**CMD 26-M13.31**

**Written Submission from the  
Radiation Safety Institute of  
Canada**

**Mid-term update from BWXT Nuclear  
Energy Canada Inc. on licensed activities  
at its Toronto and Peterborough facilities**

# **Review of the BWXT Nuclear Energy Canada Inc. mid-term update on licensed activities at its Toronto and Peterborough facilities**

**Figure 3 Graph of BWXT air monitoring results for the Peterborough facility for the 5-year period of 2021-2025.**

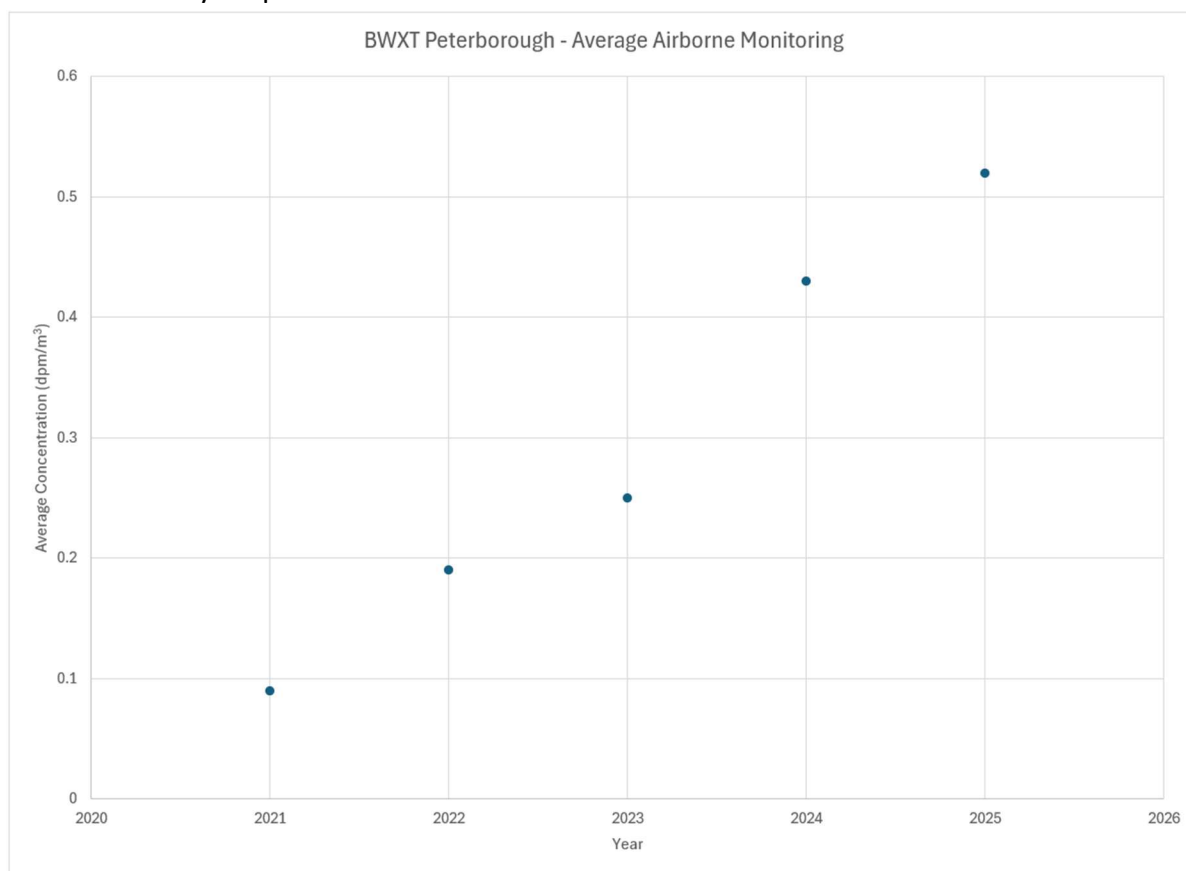
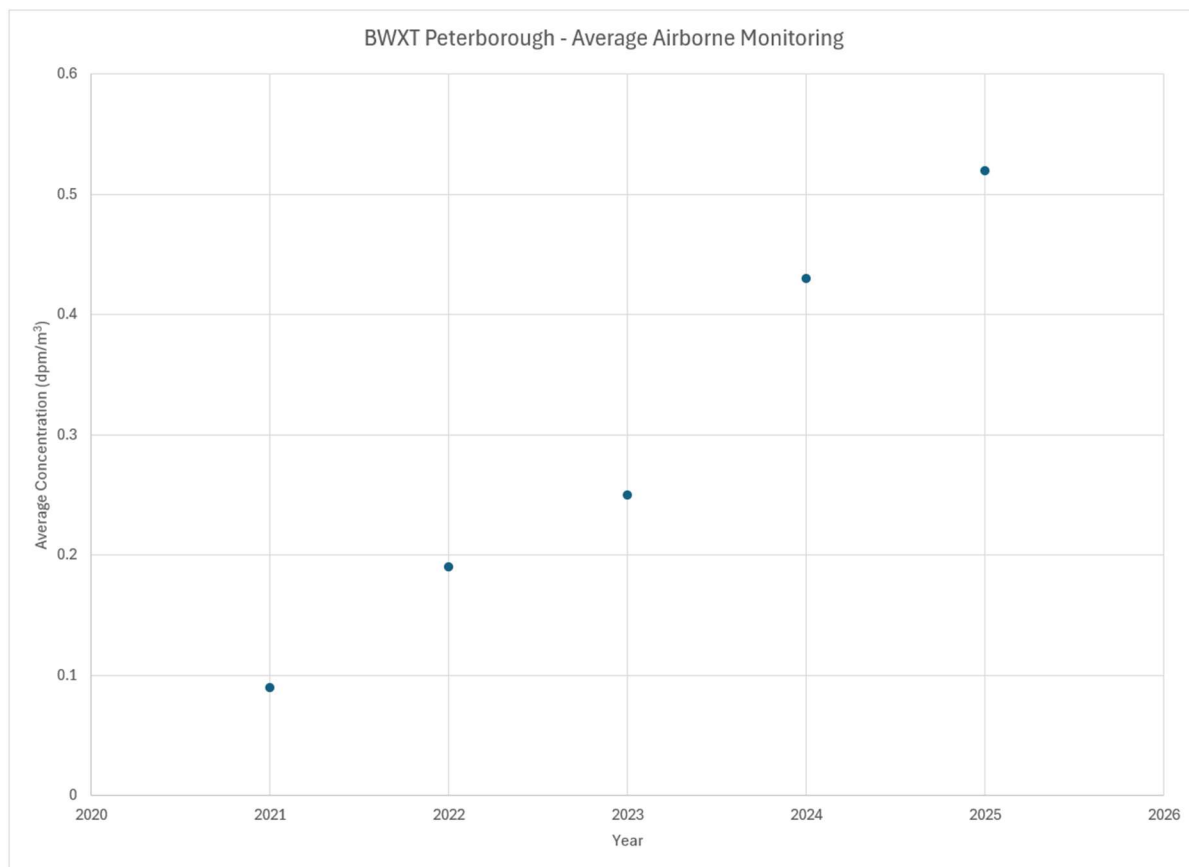
It was noted that the average airborne radioactivity concentration has increased steadily over the 5-year period of this licence, from 0.09 dpm/m<sup>3</sup> (or approximately 0.0015 Bq/m<sup>3</sup>) in 2021 to 0.52 dpm/m<sup>3</sup> (0.0087 Bq/m<sup>3</sup>) in 2025. The average concentration has increased more than 5 times in this 5-year period. This is shown in

Figure 3 below (RSIC-created graphs of BWXT results from the BWXT submission). Although even the maximum average airborne concentration is still low when compared to the DAC, the increasing trend is obvious, and it is recommended that BWXT NEC pay particular attention to the airborne radioactivity within the facility and act before the elevated results cause increases in contamination and/or dose to workers.

Figure 4 CNSC IEMP soil sampling results for beryllium for the Peterborough facility, with linear trendline.

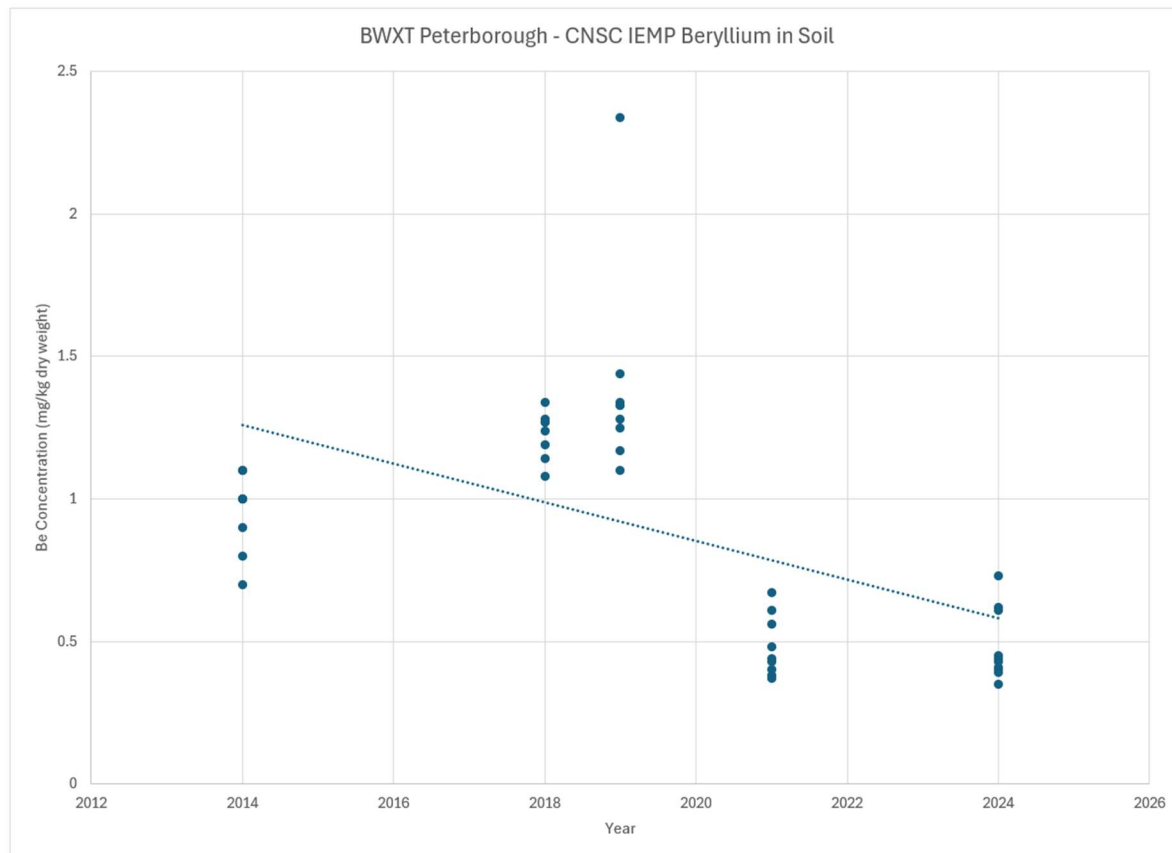
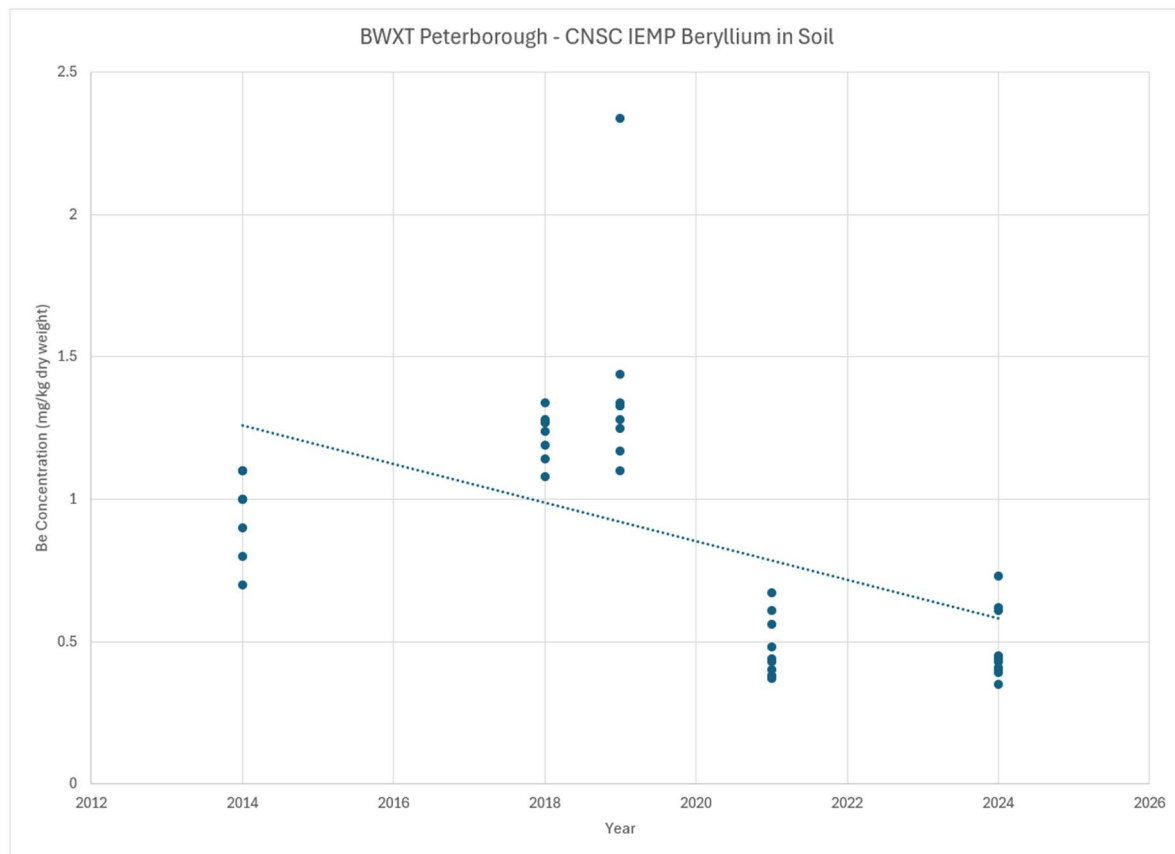
Detailed CNSC IEMP results are available for BWXT's Peterborough facility via the CNSC website (<https://www.cnsccsn.gc.ca/eng/resources/maps-of-nuclear-facilities/iemp/bwxt-peterborough/>). All air sampling results (2014-2024 inclusive) are well below the CNSC-reported guideline reference levels for both uranium and beryllium concentration. Soil sampling results (2014-2024) are also below the applicable guideline reference levels for both uranium and beryllium concentrations. The maximum soil beryllium concentration was 2.34 mg/kg, found at location GP05 in 2019 (approximately half of the 4.0 mg/kg guideline level). The maximum uranium concentration found was 2.05 mg/kg, at location G08, also in 2019 (approximately 10% of the 23 mg/kg guideline level). In fact, analysis of the results shows a decreasing trend for concentrations of beryllium and uranium in soil, as can be seen in

Figure 7 BWXT NEC's reported worker Effective Dose Equivalent showing both average and maximum worker doses from 2021 to 2025.

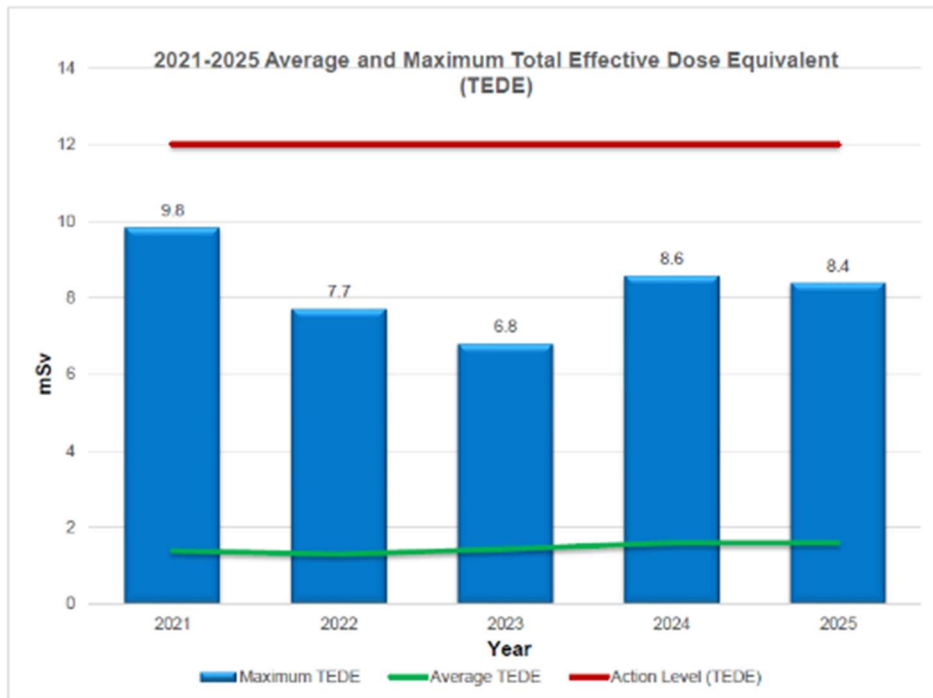
Radiation exposure levels among personnel at the Peterborough facility have remained consistently low over the five-year period from 2021 to 2025, based on monitoring with external dosimeter badges. Although there was a minor increase in average doses received by technicians during this interval, overall values remain below established Action thresholds, indicating compliance with safety standards. The following two figures, below, copied from BWXT's report show that worker doses have been on average low, and even the maximum doses have been well below regulatory limits.
